# ZULEJKIC GUEST PROPERTY

A RENOVATION FOR:  
DAVID ZULEJKIC

ISSUE DATES		
8 . 8 . 22	PERMIT	
1 . 10 . 23	REVISION 1	△

REVIEWED  
FOR  
CODE  
COMPLIANCE  
04/27/2023

DRAWN BY: SMS  
REVIEWED BY: CWM  
PROJECT # 22064  
BUILDING SECTION,  
TYPICAL WALL  
SECTION, & GA  
FILES

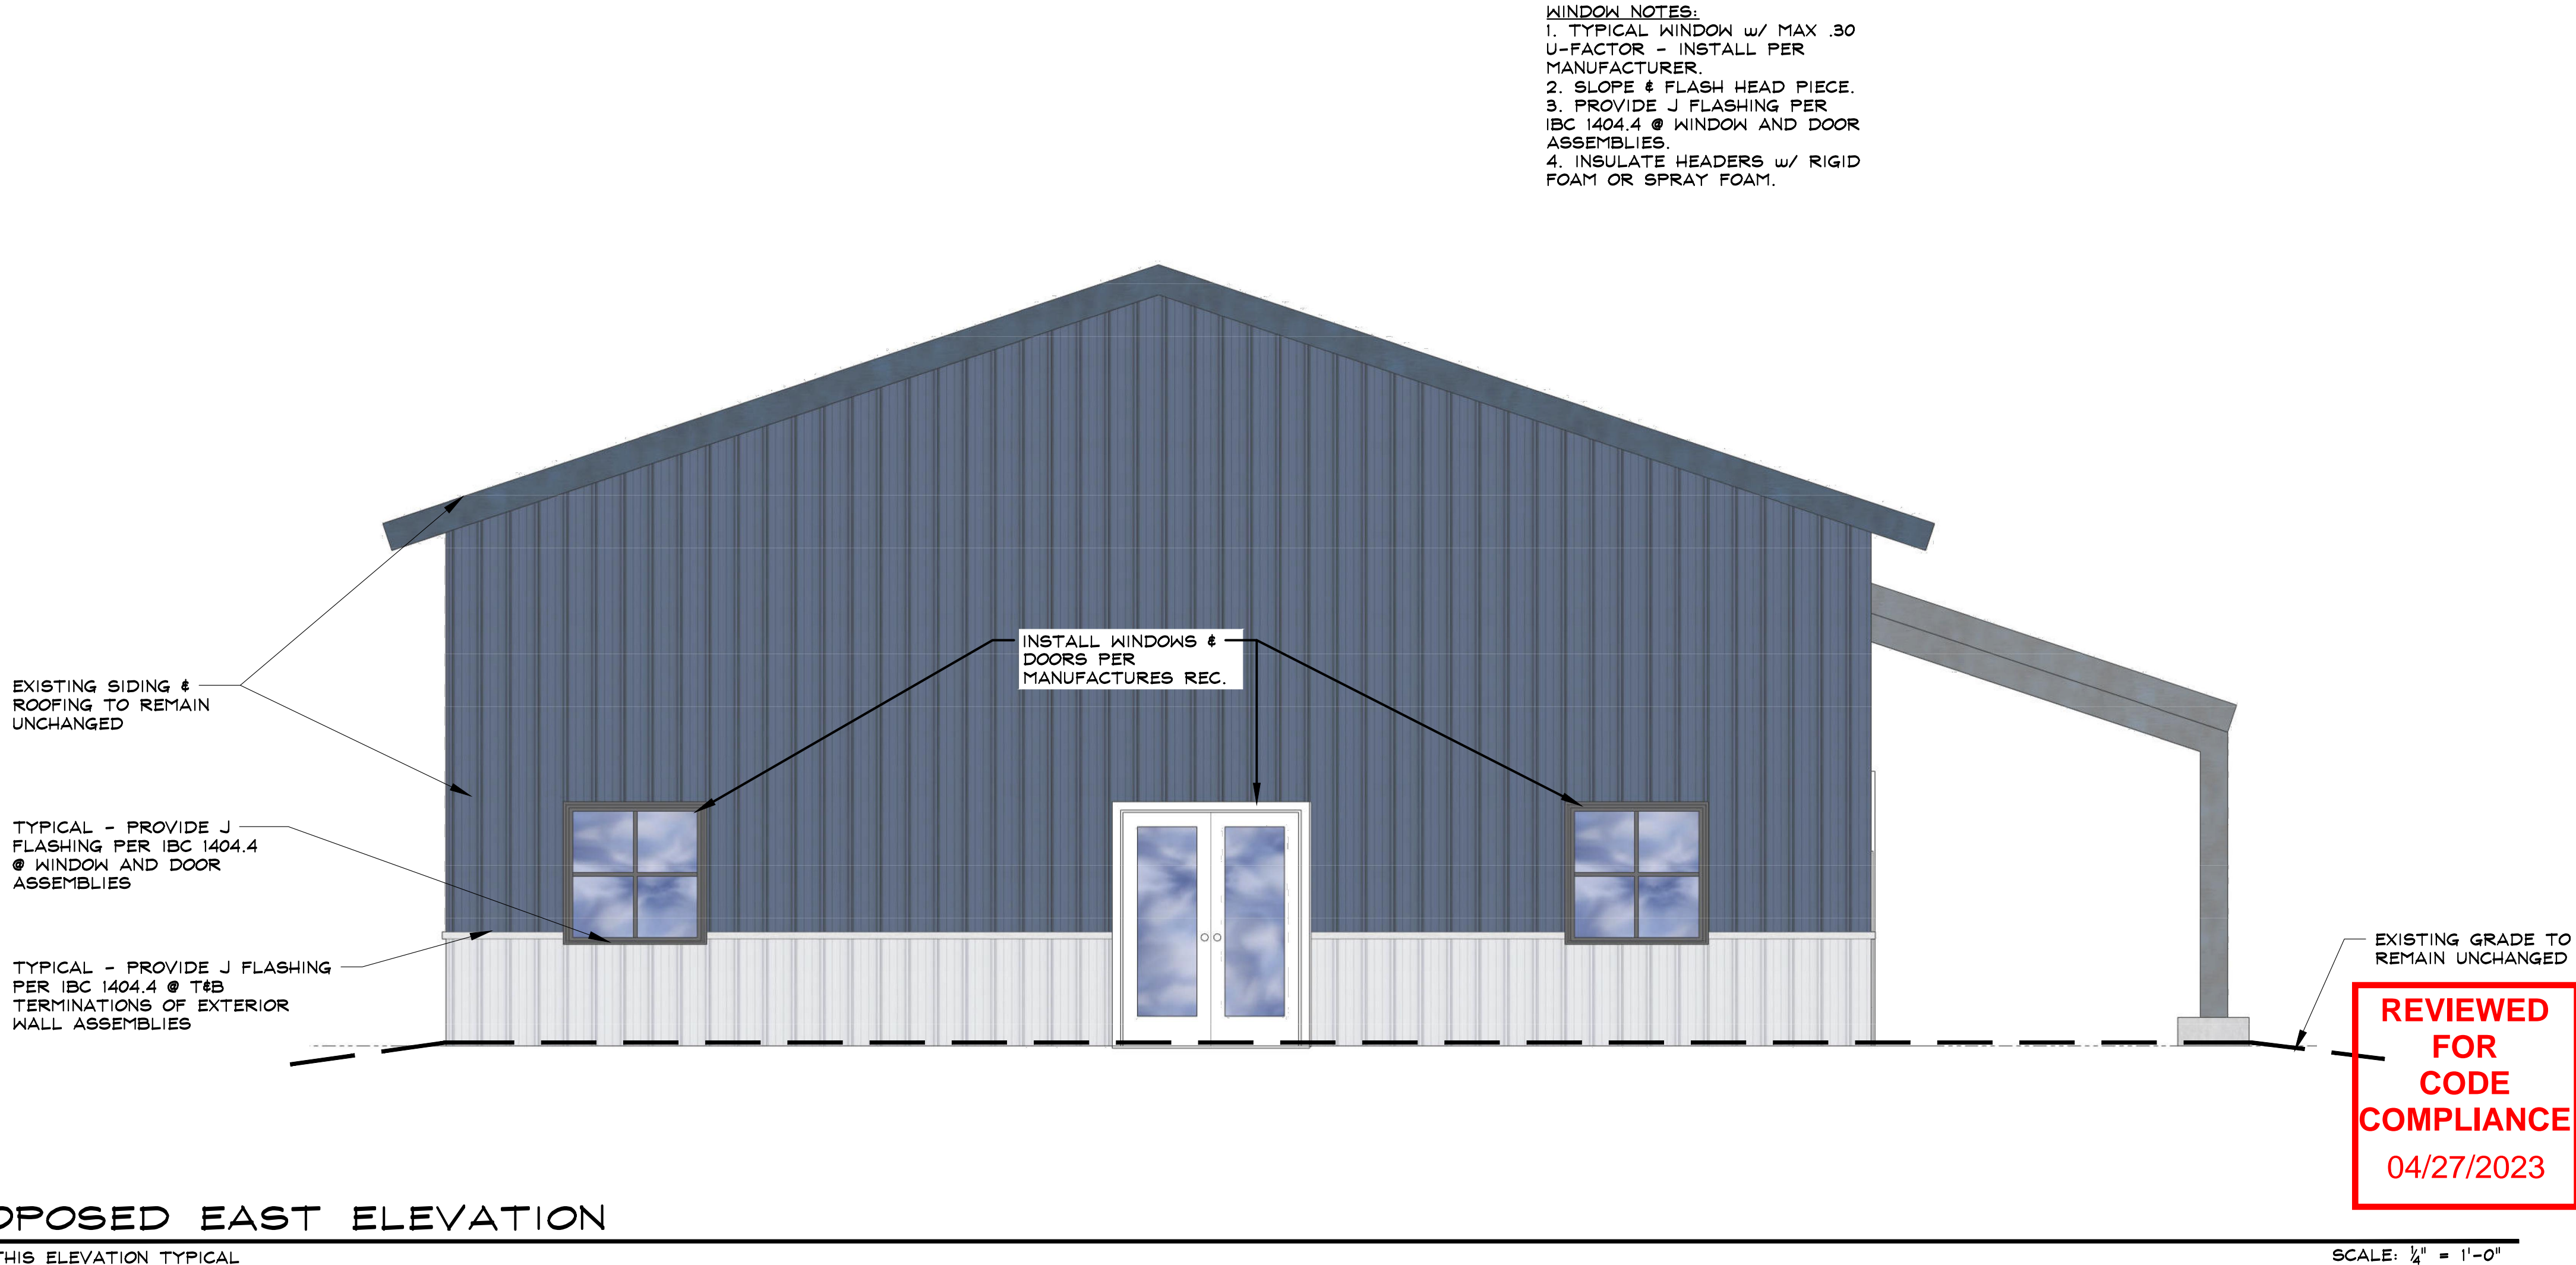
Are these walls supporting in floor/ceiling assembly with wood joists or wood trusses and are the structure from collapse if a fire is exposed to the walls?
